**Draft Melbourne Planning Scheme Amendment C401melb
1 Spring Street and 21-25 Flinders Lane, Melbourne**

Advisory Committee Report

1 May 2023

Figure 10 Re-design staircase to level 3 plaza (Source: SK-223 dated 20 March 2023)⁵¹

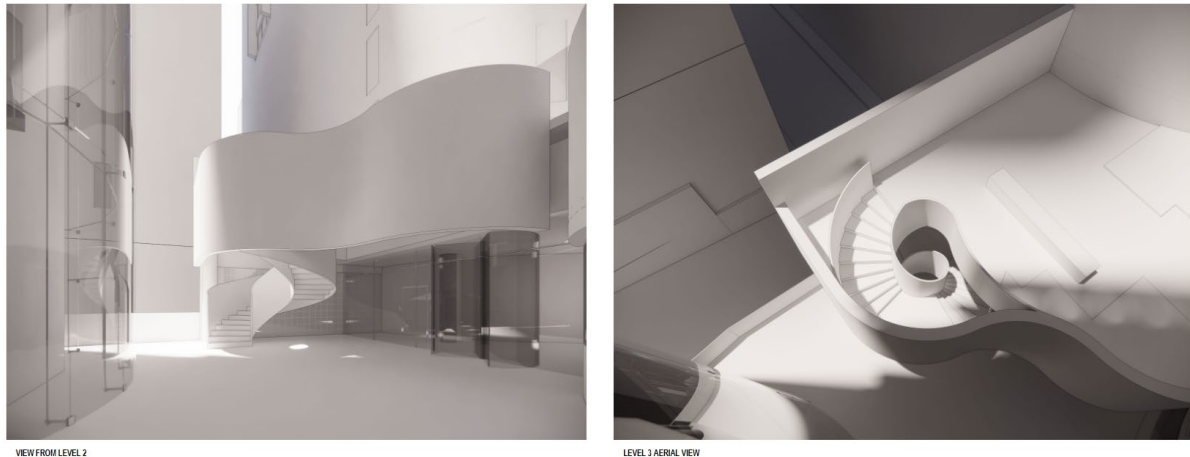
questions it asked of Mr Czarny and Mr Holman in relation to the pedestrian staircase connecting the plaza with the level 3 space above. Mr Holman was asked to consider this and produced a plan (Document 142) which showed a modified version of the stairs up to the level 3 roof garden from level 2 (see Figure 10).

The Committee considers this revised design to be a superior response as it provides better connectivity, while respecting and maintaining the Seidler philosophy and design.

- a) modify the architectural plans prepared by Ingenhoven, Architectus and Harry Seidler and Associates Pty Ltd dated 13 January 2023 and marked Revision J to show the redesign of the stairs up to the Level 3 roof garden from Level 2 in accordance with SK—221, SK-222 and SK-223 dated 20 March 2023.**
